Contract #: 04-0120F4Cty: SF/ALA Rte: 80 PM: 13.2/13.9File #: 69.25B**QUALITY ASSURANCE -- NON-CONFORMANCE REPORT****Location:** Changxing Island, Shanghai, P.R. China**Report No:** NCR-000691**Prime Contractor:** American Bridge/Fluor Enterprises, a JV**Date:** 27-Feb-2010**Submitting Contractor:** Zhenhua Port Machinery Company, Ltd (ZPMC), Changxing Island**NCR #:** ZPMC-0658**Type of problem:**

Reference Description: Free hand thermal cutting over 300mm in length without Engineer's approval
(Segment 12AW and 12BW FB)

Subject: NCR No. ZPMC-0658

Subject: NCR No. ZPMC-0658

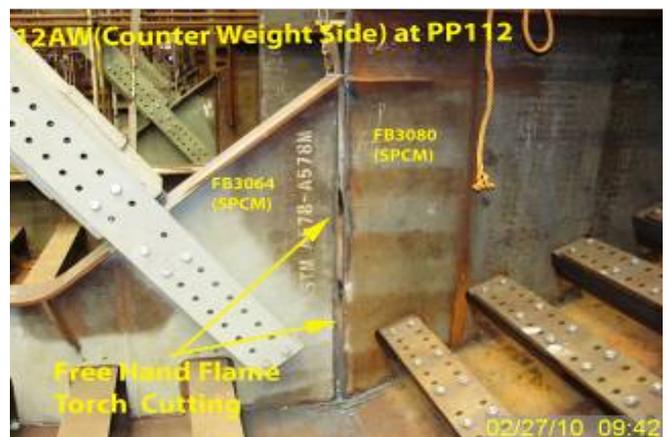
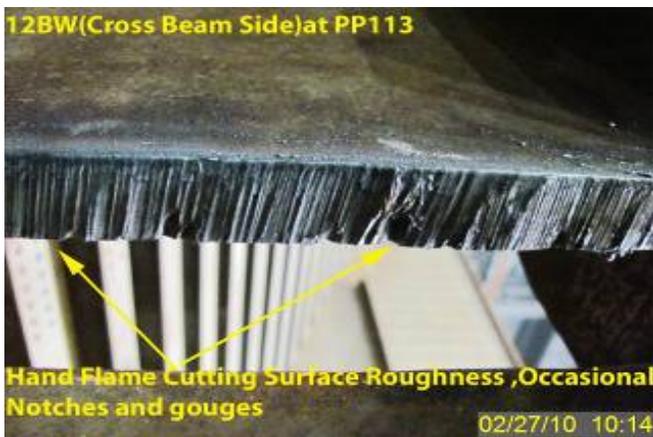
During Quality Assurance random in-process observations of the fabrication of segment 12AW and 12BW, this Quality Assurance Inspector (QA) discovered the following issue:

- ZPMC personnel have performed Free Hand Flame Cutting for more than 300mm in length at the locations listed.
- The approximate cut length for Floor Beam FB3072 plate number X3166D measured 1025mm from the Bottom Plate on panel point (PP) 111.5, Counter Weight side.

- The approximate cut length for Floor Beam FB3079 plate number X3207M measured 4700 mm from the Bottom Plate on PP111.5, Counter Weight side.
- The approximate cut length for Floor Beam FB3064 plate number X33267B (SPCM) measured 1500 mm from the Bottom Plate on PP112, Counter Weight side.

- The approximate cut length for Floor Beam FB3080 plate number X3183D (SPCM) measured 4700 mm from the Bottom Plate on PP112, Counter Weight side.
- The approximate cut length for Floor Beam FB3070 plate number X3166A measured 1025 mm from the Bottom Plate on PP112.5, Counter Weight side and 1025 mm from Bottom Plate on the Cross Beam side.

- The approximate cut length for Floor Beam FB3083 plate number X3207A measured 2000 mm from the Bottom Plate on PP112.5, Cross Beam side.
- The approximate cut length for Floor Beam FB3066 plate number X3267E measured 1500 mm from the Bottom Plate on PP113, Cross Beam side.

- The approximate cut length for Floor Beam FB3085 plate number X3181D measured 2000 mm from the Bottom Plate on PP113, Cross Beam side.
- All the Floor Beam plate materials listed above are less than 25mm in thickness.

Reference Description: Free hand thermal cutting over 300mm in length without Engineer's approval
(Segment 12AW and 12BW FB)

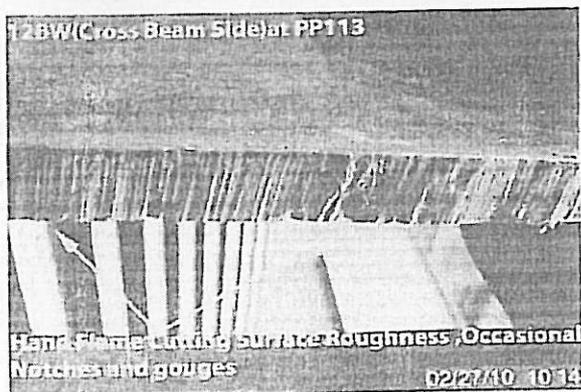
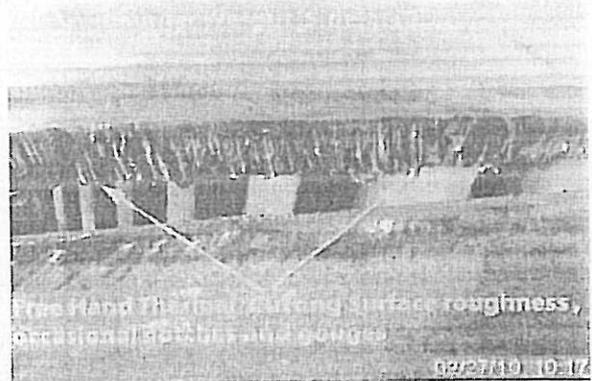
During Quality Assurance random in-process observations of the fabrication of segment 12AW and 12BW, this Quality Assurance Inspector (QA) discovered the following issue:

- ZPMC personnel have performed Free Hand Flame Cutting for more than 300mm in length at the locations listed.
- The approximate cut length for Floor Beam FB3072 plate number X3166D measured 1025mm from the Bottom Plate on panel point (PP) 111.5, Counter Weight side.

- The approximate cut length for Floor Beam FB3079 plate number X3207M measured 4700 mm from the Bottom Plate on PP111.5, Counter Weight side.
- The approximate cut length for Floor Beam FB3064 plate number X33267B (SPCM) measured 1500 mm from the Bottom Plate on PP112, Counter Weight side.

- The approximate cut length for Floor Beam FB3080 plate number X3183D (SPCM) measured 4700 mm from the Bottom Plate on PP112, Counter Weight side.
- The approximate cut length for Floor Beam FB3070 plate number X3166A measured 1025 mm from the Bottom Plate on PP112.5, Counter Weight side and 1025 mm from Bottom Plate on the Cross Beam side.

- The approximate cut length for Floor Beam FB3083 plate number X3207A measured 2000 mm from the Bottom Plate on PP112.5, Cross Beam side.
- The approximate cut length for Floor Beam FB3066 plate number X3267E measured 1500 mm from the Bottom Plate on PP113, Cross Beam side.

- The approximate cut length for Floor Beam FB3085 plate number X3181D measured 2000 mm from the Bottom Plate on PP113, Cross Beam side.
- All the Floor Beam plate materials listed above are less than 25mm in thickness.

Before start frame cutting, a steel bar was fixed on web to work as the guide plate for frame cutting.

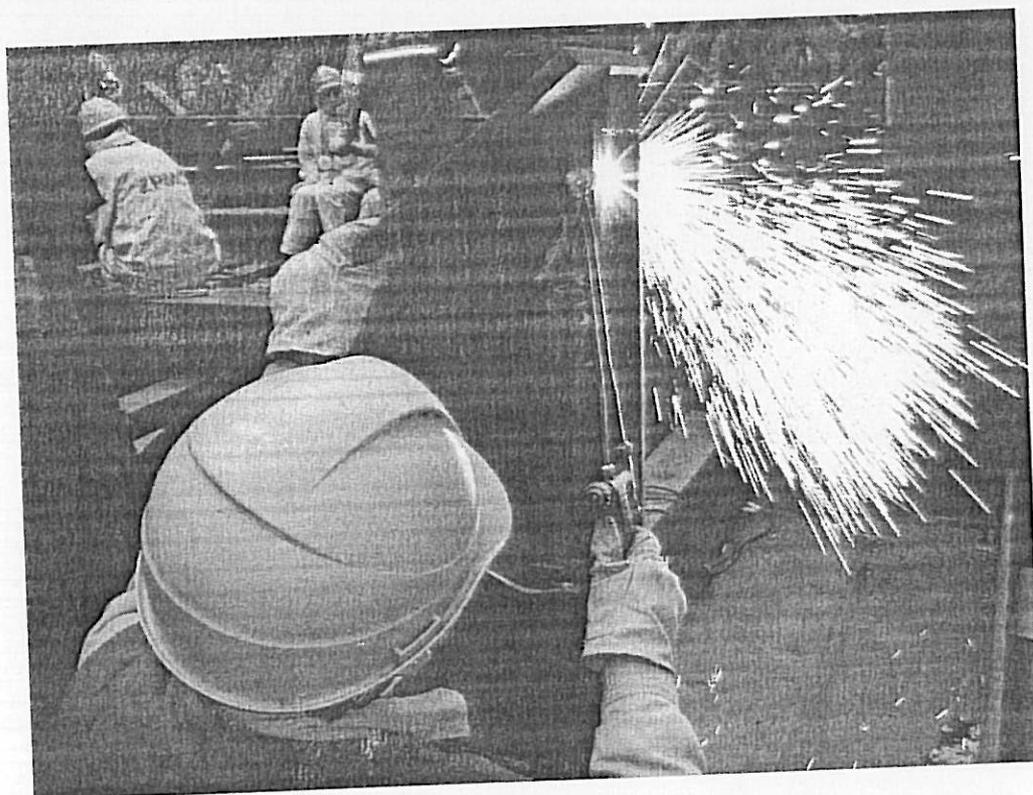
ZPMC is clarifying that there is a misunderstanding with CT's representative. Attached photos show the cutting method what ZPMC used on site. One steel bar was fixed on the web of floor beam and the frame cutting operator was cutting the allowance along with this steel bar (guide plate). After confirmed with ABF QCM, this method should not be deemed to be free hand cutting. Please also be noticed, the cut areas have been confirmed to be allowance on webs and no damage was occurred on base metal. Based on this, ZPMC is requesting closure for this NCR.

The method as shown in the provided photos was not utilized at the locations noted in the NCR. The Contractor shall determine why free-hand flame cutting was performed in these areas and how to prevent future occurrences.

PHOTOS FOR FLOOR BEAM CUT EDGES

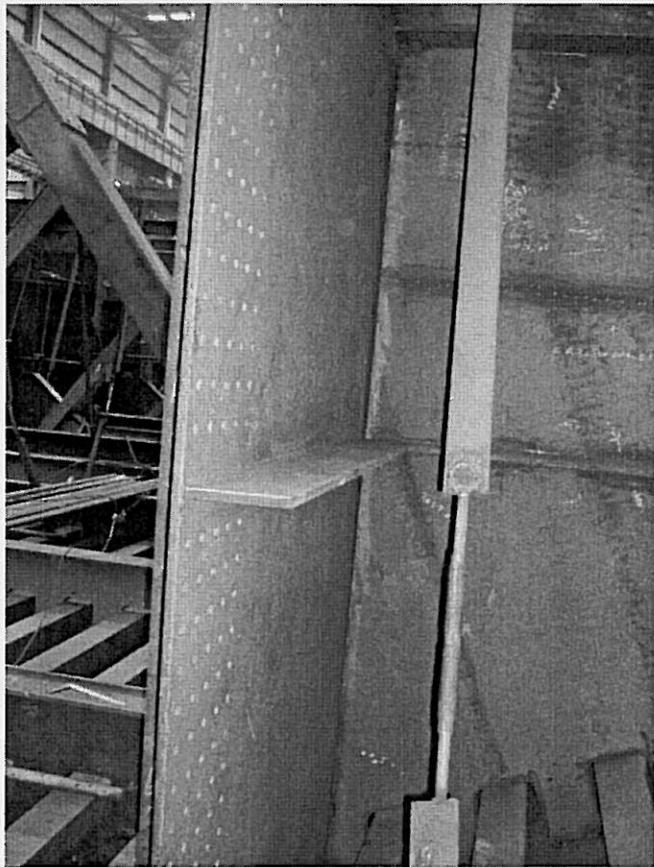
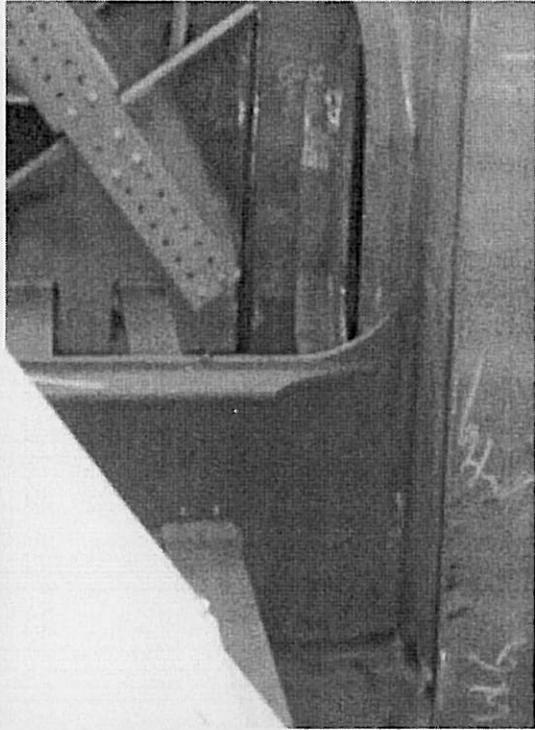
ZPMC acknowledged wrong cutting procedure was performed and has written an internal NCR. The approved freehand thermal cutting procedure has been released to all related department to prevent same cases' occurrences again. It was found no base metal as designed was damaged after cut, due to these cutting was performed within the allowance of material. Please review the attached photos show after grinding the cut edges are satisfactorily. Based on this, Please consider closure of this NCR.

This proposed resolution is acceptable. The documentation received is sufficient and the Department concurs that Non-Conformance ZPMC-0658 is closed.

Reference Description: Free hand thermal cutting over 300mm in length without Engineer's approval
(Segment 12AW and 12BW FB)

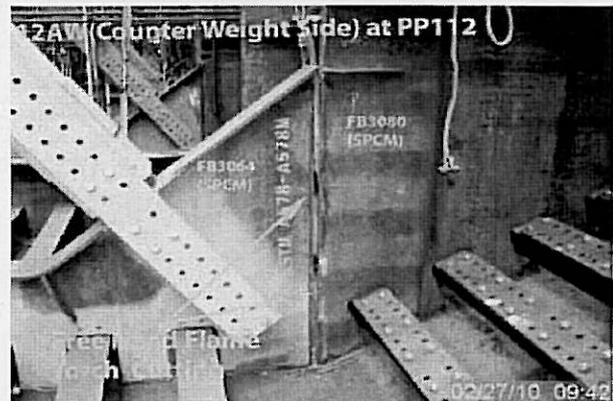
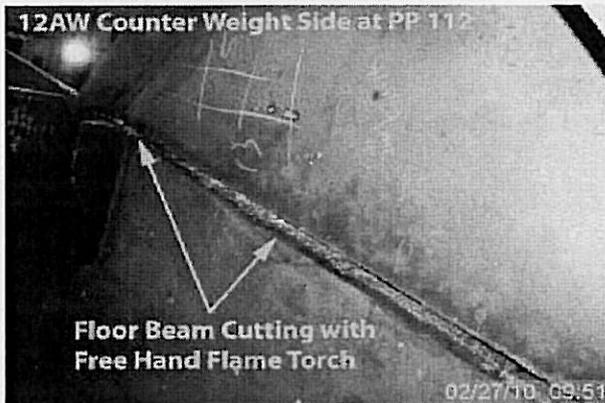
During Quality Assurance random in-process observations of the fabrication of segment 12AW and 12BW, this Quality Assurance Inspector (QA) discovered the following issue:

- ZPMC personnel have performed Free Hand Flame Cutting for more than 300mm in length at the locations listed.
- The approximate cut length for Floor Beam FB3072 plate number X3166D measured 1025mm from the Bottom Plate on panel point (PP) 111.5, Counter Weight side.

- The approximate cut length for Floor Beam FB3079 plate number X3207M measured 4700 mm from the Bottom Plate on PP111.5, Counter Weight side.
- The approximate cut length for Floor Beam FB3064 plate number X33267B (SPCM) measured 1500 mm from the Bottom Plate on PP112, Counter Weight side.

- The approximate cut length for Floor Beam FB3080 plate number X3183D (SPCM) measured 4700 mm from the Bottom Plate on PP112, Counter Weight side.
- The approximate cut length for Floor Beam FB3070 plate number X3166A measured 1025 mm from the Bottom Plate on PP112.5, Counter Weight side and 1025 mm from Bottom Plate on the Cross Beam side.

- The approximate cut length for Floor Beam FB3083 plate number X3207A measured 2000 mm from the Bottom Plate on PP112.5, Cross Beam side.
- The approximate cut length for Floor Beam FB3066 plate number X3267E measured 1500 mm from the Bottom Plate on PP113, Cross Beam side.

- The approximate cut length for Floor Beam FB3085 plate number X3181D measured 2000 mm from the Bottom Plate on PP113, Cross Beam side.
- All the Floor Beam plate materials listed above are less than 25mm in thickness.

Grind area in question smooth prior to welding.
